REQUEST FOR BIDDING INTERPRETATION (RFBI)

PMDB RFBI No.: 26

Project Name: DSH-Coalinga Hydronic Loop Replacement

Drawing Reference: Sheet M-4.38C Project Manual Reference: _____

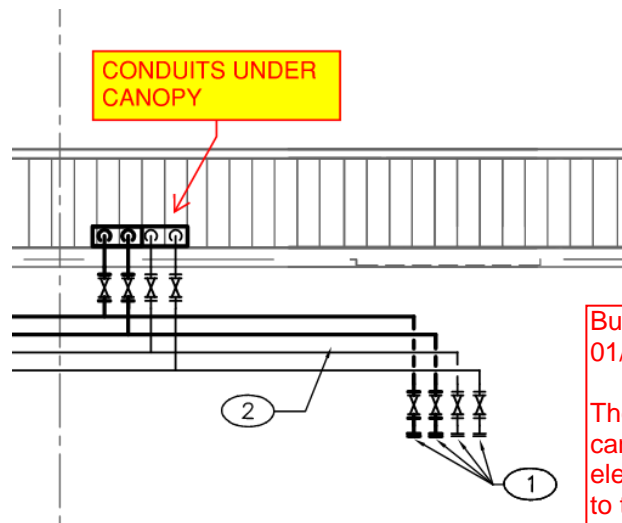
Question: Please reference the plan sheet comments shown below.

Based on the project walk, it appears that there are potential electrical conduit conflicts for the hot water connections within Building 38.

Please advise how the Contractor should address this situation in the bid and/or if the Owner will issue a revised drawing.

The pipes should penetrate the canopy where they will miss the electrical conduits and then route back to the exterior side of the wall to drop down along the wall.
